ADDENDUM 1 – JOB 24569

TO: All prospective bidders on Project TMA-CRP-TA-8-992(056), Job No. 24569 scheduled for the November 14, 2025 bid opening.

PLAN ADDENDUM SUMMARY AND APPROVAL

Sign Summary
 Perforated Tube
 8th Street West Multi-Use Path
 5th Ave W to 12 1/2 Ave W

STATE	PROJECT NO.	SECTION NO.	SHEET NO.
ND	TMA-CRP-TA-8-992(056)	110	2

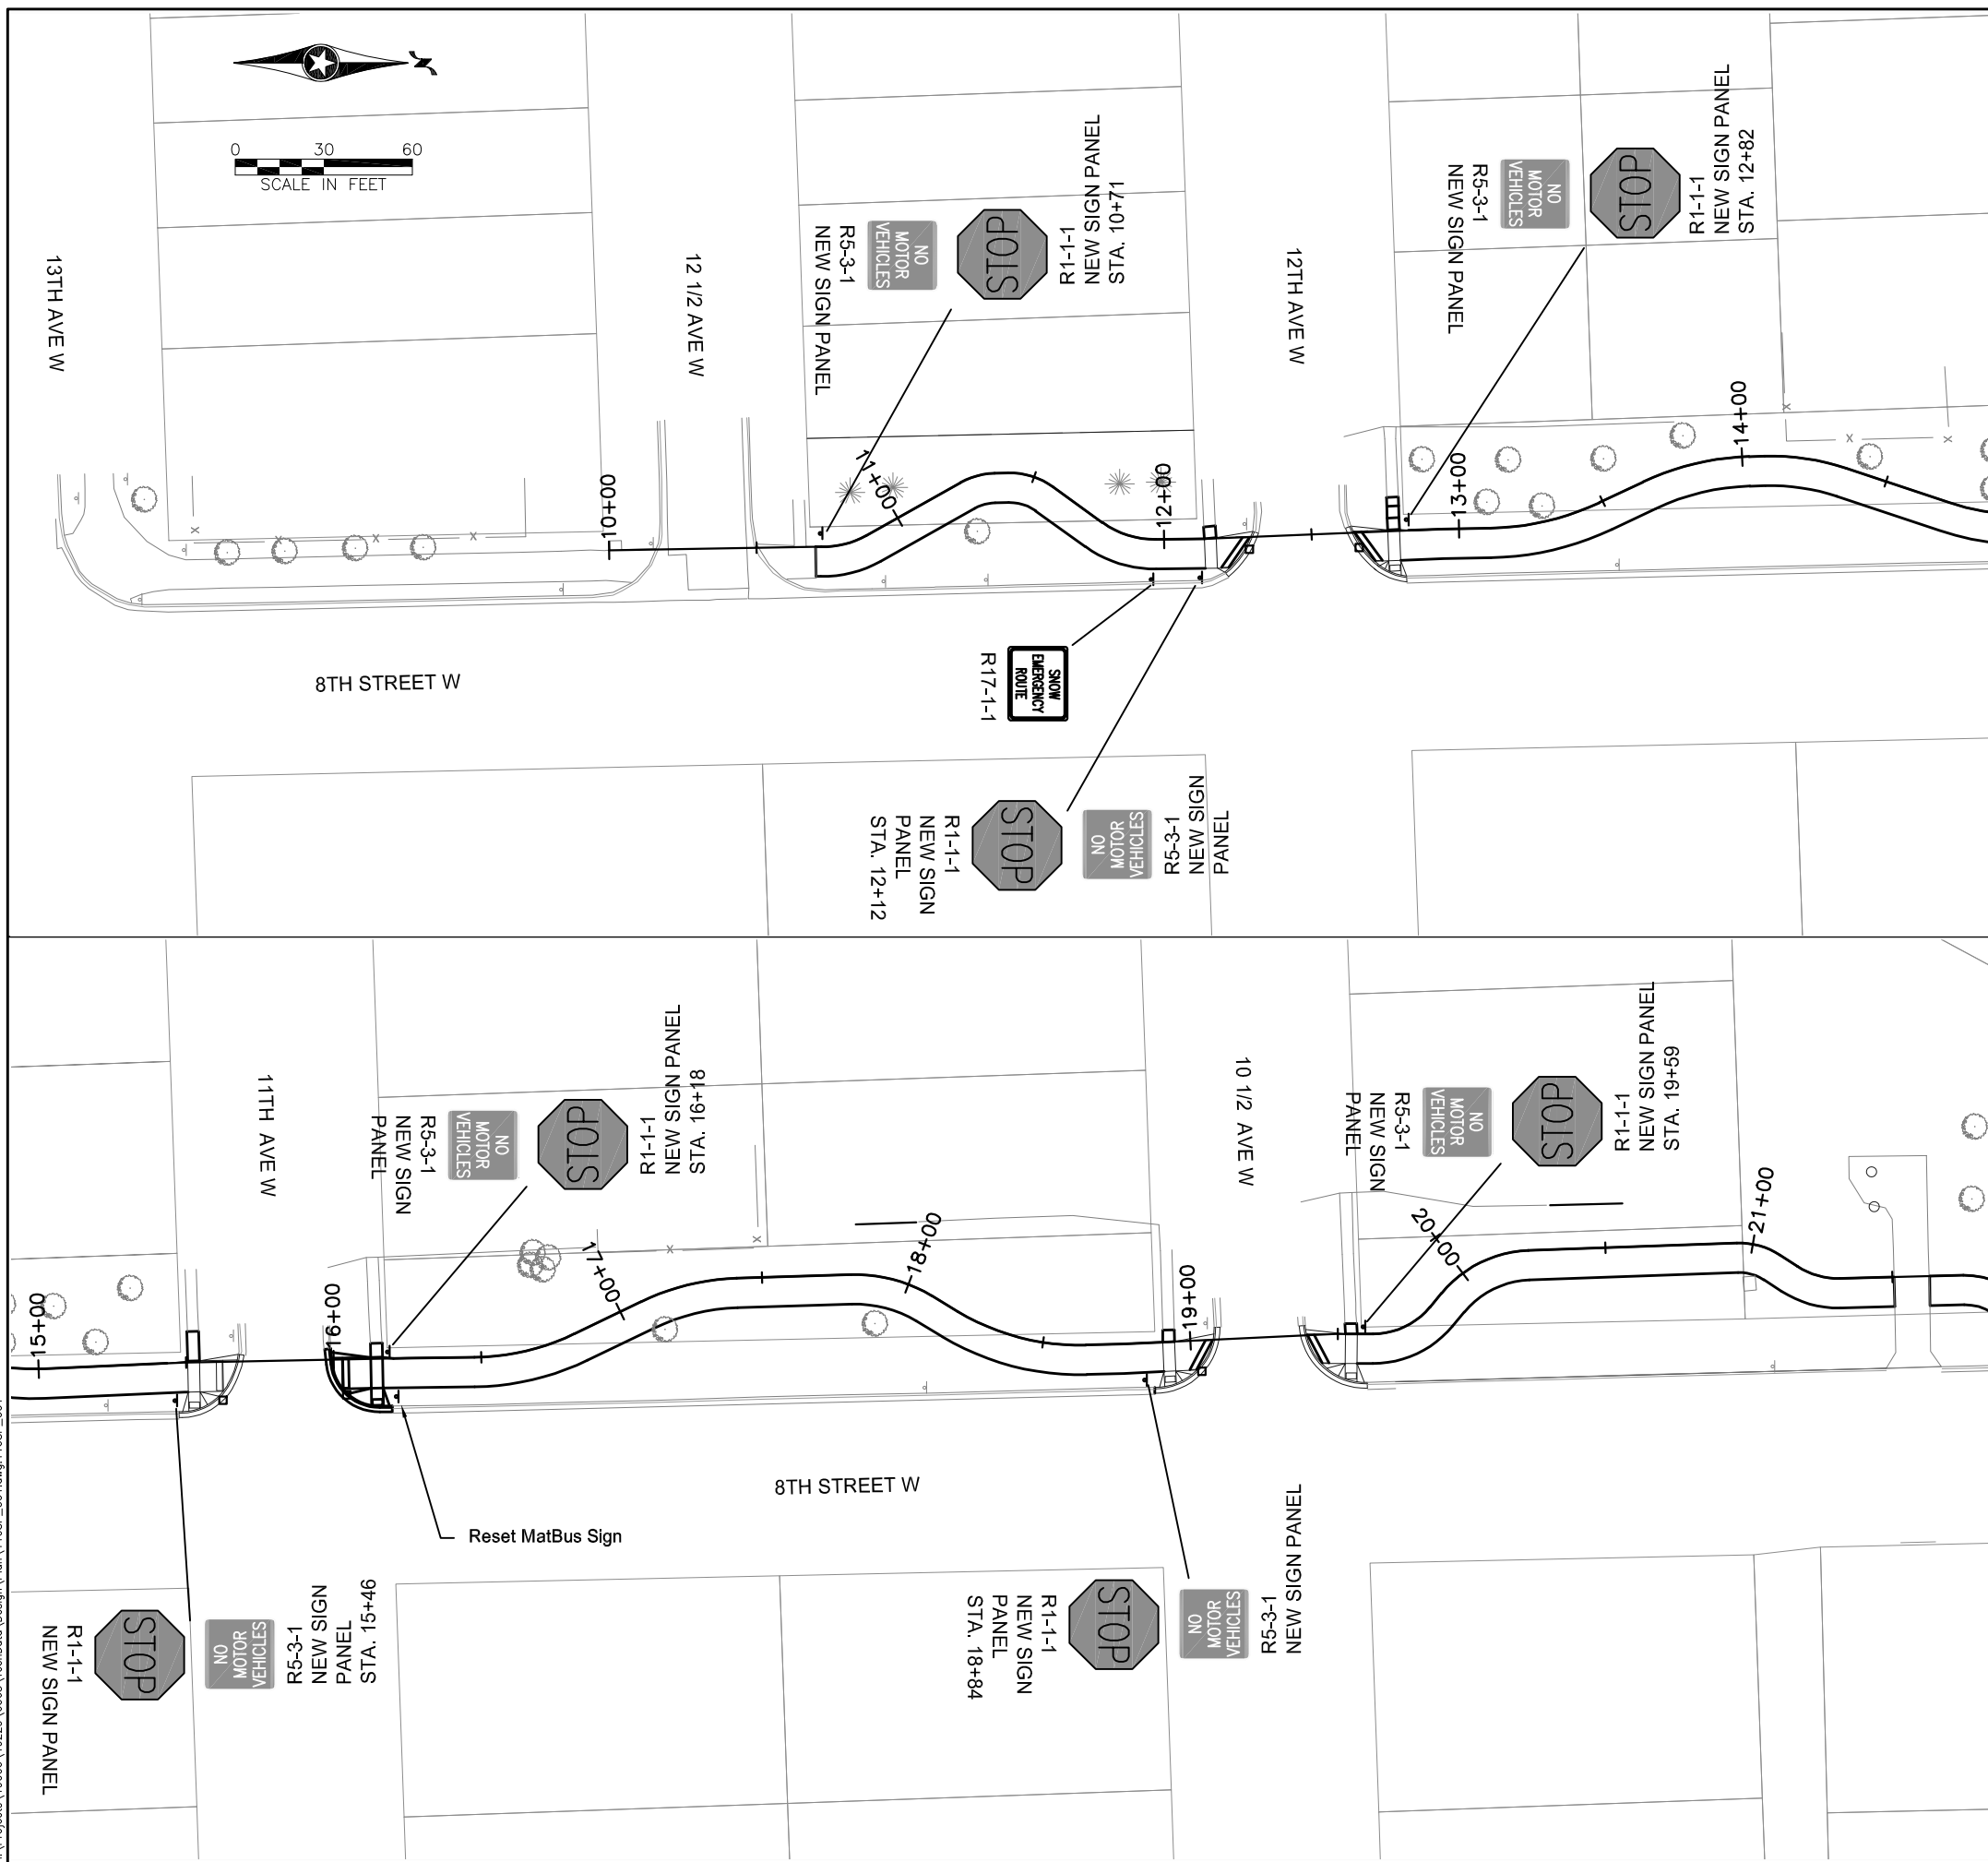
PLAN SHEET CHANGES		
Section	Sheet(s)	Description
8	1	Revised Reset Sign Panel and Reset Sign Support quantities and added Flat Sheet For Signs-Type XI Refl Sheeting and Steel Galv Posts-Telescoping Perforated Tube.
110	1-3	Revised Stop Sign and No Motor Vehicles signs from Reset sign panel and Reset Sign support to New Sign Panel.

SPEC	CODE	BID ITEM	QTY	UNIT
754	0592	RESET SIGN PANEL Sta 11+96 - 14' RT Sta 16+21 - 13' RT	1 1	EA EA
754	0593	RESET SIGN SUPPORT Sta 11+96 - 14' RT Sta 16+21 - 13' RT	1 1	EA EA
